SB: Wall mounted hose boxes rollup 15, 25, 35 and 35Li

Article : 8022, 8023, 8024 and 8025

Reason: Several improvements on the products since production start.

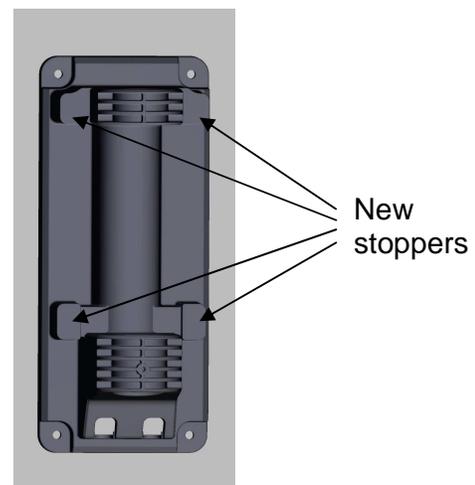
- Deformed wall holders caused by influence of heat: the box housings were reinforced since index "D343"
